26 May 2025

Council Reference: A006710893 (Minor Change); A006534875 (Original Approval)

**RE: Response to Further Issues Request – Minor Change Application over 37  
Ross Street and & 176 Breakfast Creek Rd, Newstead**

**Figure 1: Tower Facing Breakfast Creek Road - Demonstrating the design rationale of breaking the Tower Form into separate components and emphasising the corner treatment (Source: Plazibat Architects Design Report)**

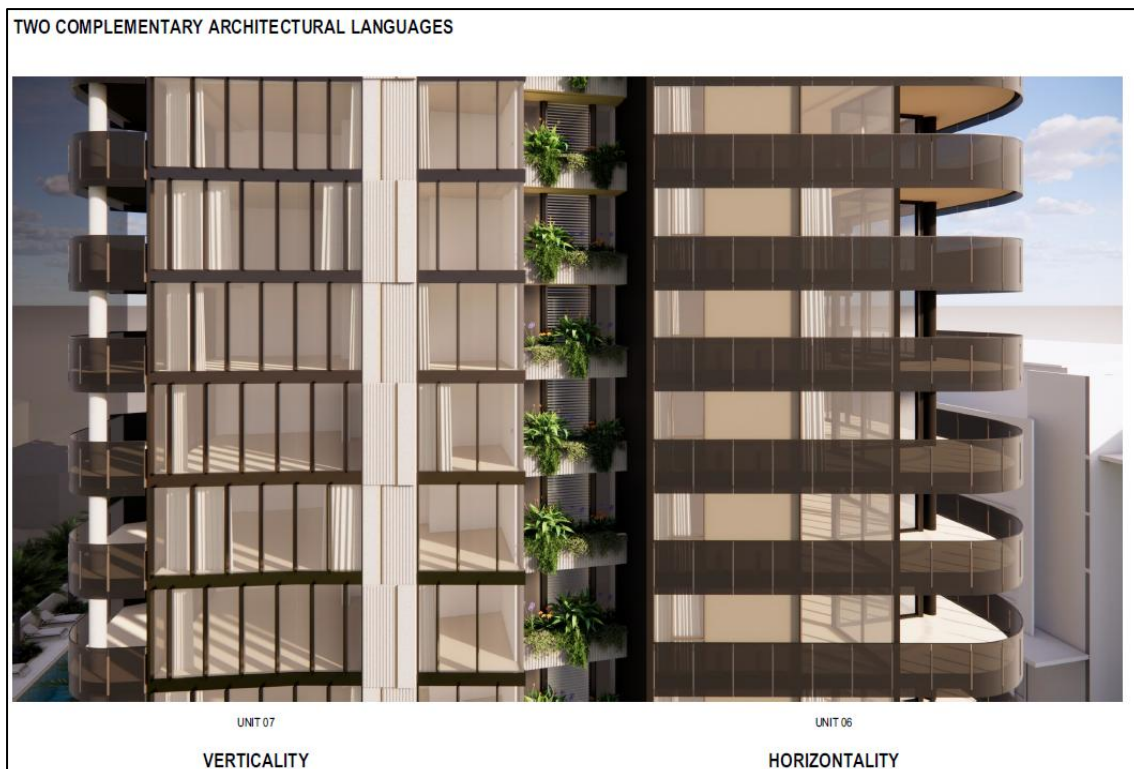
To address Council's request that the proposed façade of the residential tower addressing Breakfast Creek Road and Durong St (shown as units 06 and 07) be given more distinction, the following has been provided:

- The units that address the corner of Breakfast Creek Road and Durong St (shown as Units 06) have been refined to strengthen the architectural expression and are expressed 'horizontally', with key improvements being:
  - A larger corner balcony to assist with providing more accentuation at the corner and improve liveability. The balcony has been pushed out 600mm towards Durong Street;
  - A strong dark balustrade band that extends above and below the slab and wraps around the entire unit, creating a horizontal gesture that defines the architectural expression of the corner;
  - The sliding screen removed from the balcony edge to assist with banding definition of the corner.

- The units that face east on to Breakfast Creek Road (shown as Units 07) have been given a distinct architectural language distinct from Units 06 that emphasises ‘verticality’, in contrast to the horizontal lines of Units 06. Improvements include:

- Uninterrupted floor to ceiling glass window walls;
  - The glazing line of this part of the tower has been pushed back from the future road resumption alignment, allowing the introduction of vertical staggered fins aligned with the mullions of the window wall;

- A vertical precast textured feature wall that creates a strong and distinctive vertical element;
  - The corner balcony at the southeast edge has been increased in width by 600mm to again emphasise the corner over the adjacent body of building and improve liveability;

- Balustrade design has been changed that extends above and below the slab and is the same strong dark balustrade used in the type 06

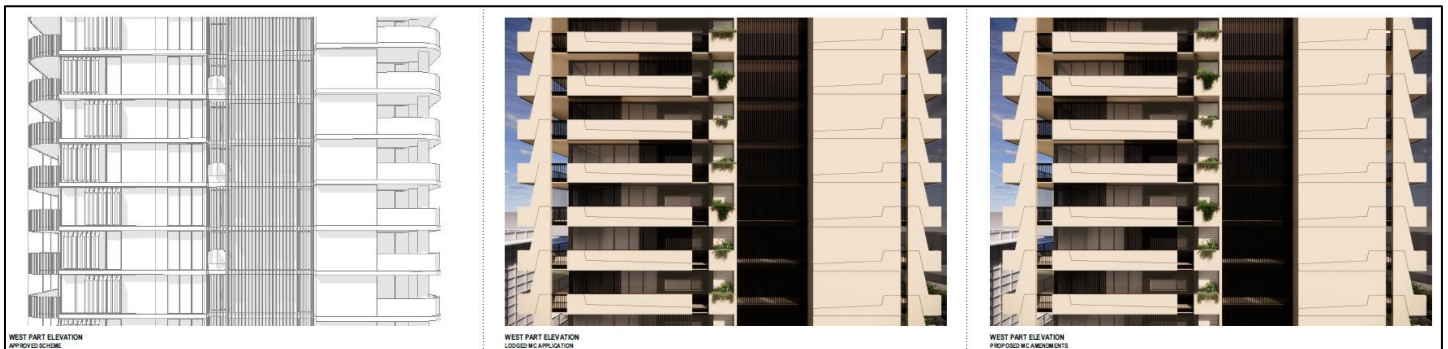
We also note that ‘stand-alone’ elevations of the South and West towers from the previous development approval were not included as part of the approval package. As demonstrated in Figures 7 and 8 which have been extracted by Plazibat Architects from the 3D model lodged as part of that previous approval, these elevations could be considered to be lacking in architectural finesse. In contrast, the lodged Minor Change elevations, and now the subsequent amended elevations, provide a high degree of architectural detailing, as shown throughout the Plazibat Architects Design Report and Plazibat Architects Design Drawings.

Figure 9: Example of Projections Deleted from Approval – Refer Att A (Source: Approved Plans A006534875)

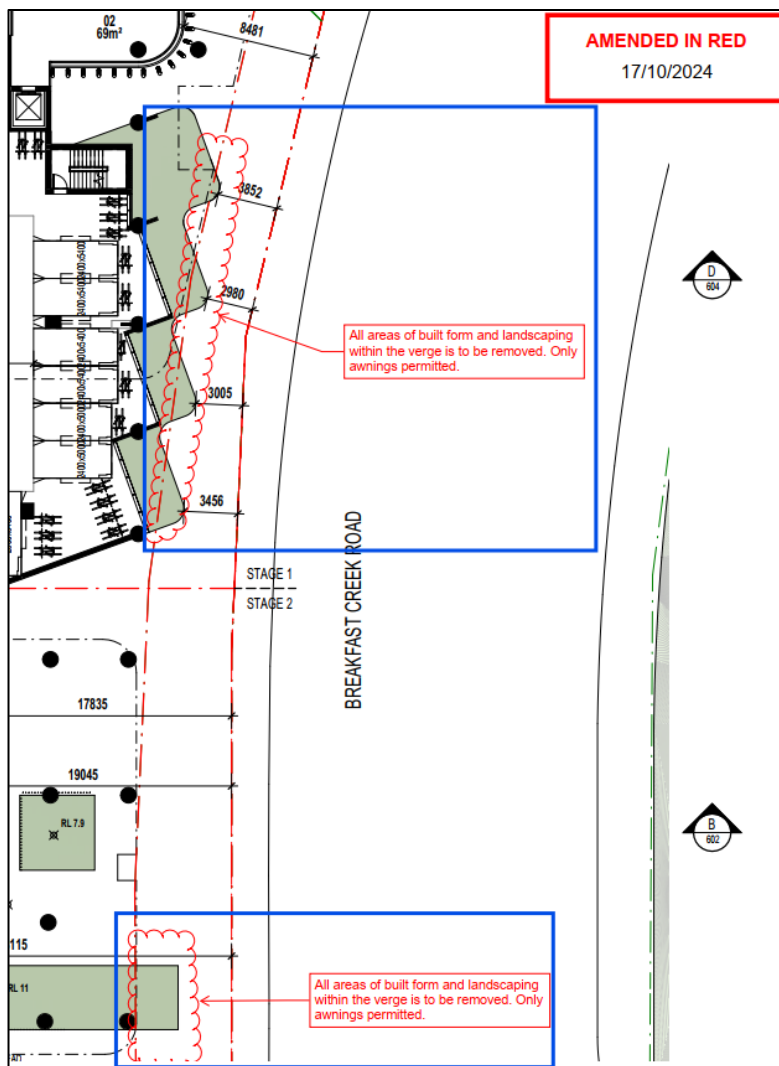
In particular, in response to Council RFI items, plans were amended by adding in projections to the eastern elevations of both the North and East towers facing Breakfast Creek Road. The added projections can be seen in the below perspectives and elevations within the blue boxes on Figures 9 and 10 and Attachment A.

However, after these additions were added to address items raised in the RFI's, they were then deleted in red on the approval.

- the projections on the southern side of the eastern elevation of the North Tower have been removed.
- Planters on the North Tower levels two and four have been removed.
- Part of the East Elevation podium planting area on level five of the north and east tower has been removed
- The screens and planters of the eastern elevation of the east tower have been marked up in red to be removed.

Consequently, the architecture of the 3D's presented to us as being the approved outcome is not representative of the final approval, where all of the projections on the eastern elevations have been removed. Therefore, the actual approved development has reduced features on the eastern elevations, resulting in 'flat' facades with incomplete architecture.

Figure 11: Setbacks of approved building are 2,602mm to the screen and 2,712mm to ledge Western  
(Source: MAS Architects and marked up by TDD)

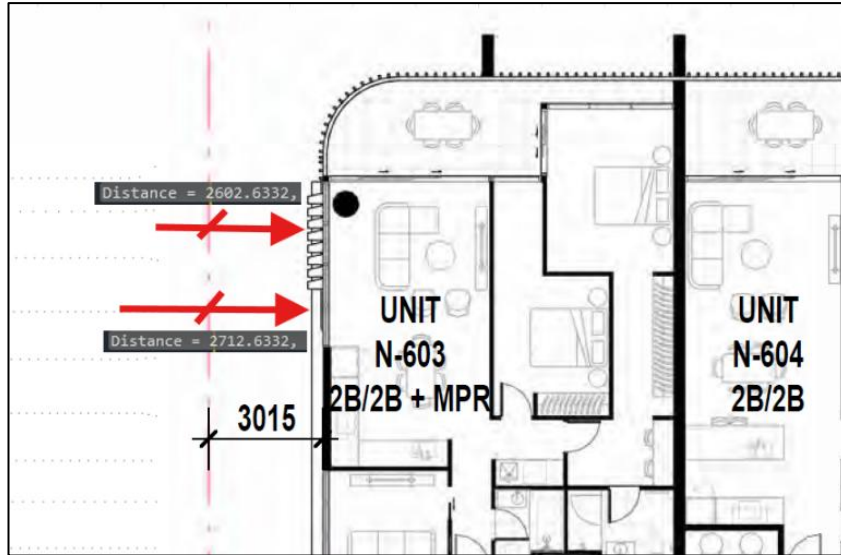
Council raised no issue with the amended northwestern side boundary setback of the tower adjacent to the low rise building in its request for amendments sent of 21 April. However, in a subsequent email dated 13 May, Council “recommended” that the balcony extension (which is now 2m from the side boundary) be removed from levels 7 to 26.

- The Setback shown on the Approved Drawings to the western boundary is 3,015mm to the wall (only 15mm different to proposed) which then has a ledge and screens extending beyond the external wall reducing the setback dimension (refer Figure 11). These protrusions result in the following lesser setbacks:
  - 2,602mm to screen
  - 2,712mm to ledge

This recommendation has been considered, however we are of the opinion that the currently proposed 2m setback to the balcony (and 3m to the wall) remains appropriate on the following grounds:

Figure 12: Diagram showing location of easements on adjoining site and proposed setbacks  
(Source: Plazibat Architect Architectural Drawings)

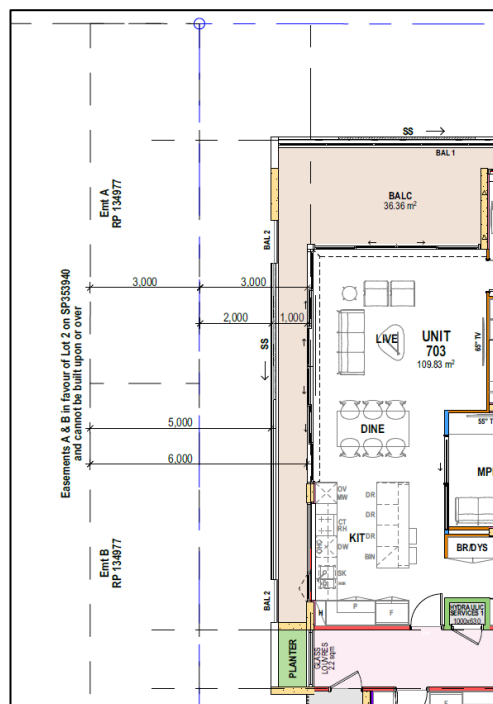
- The adjoining site contains an Easement 3m wide that runs the full length of that site’s east boundary where it abuts Lot 2 which is the subject of the current application (refer Figure 12). This easement provides access to services for Lot 2 and cannot be built on or over, and therefore ensures that on that site, no part of a building will be closer than 3m to the side boundary;

- As a consequence, the gap between the subject tower and any future tower on the adjoining site would be a minimum of 5m, and 6m to walls (refer Figure 12);

- The proposed setback is 2,000mm to the balcony (refer Figure 12) which is a difference of just 602mm to the screens or 712mm to the ledge as compared to the approved setback;
- The building facade proper (i.e. edge of external wall) is 3,000mm to the boundary and therefore complies with NCC 2022 fire separation setbacks;

- Inclusion of the balconies provides improved climatic amenity for the residents by allowing the full opening of sliding doors adjacent to the living and dining area. The solid balustrade is 1100 high and only 800 mm wide internally, therefore not wide enough for the location of any furniture, reinforcing that its purpose is to allow for the opening of sliding doors and provides a much better result for the amenity of the apartment. If the balcony was not present, window openings would be restricted to a small gap at the base of hopper windows.
- The balconies also provide the opportunity for the inclusion of sliding screens on the west-facing facade, resulting in a kinetic façade while also improving privacy outcomes and sun shielding.
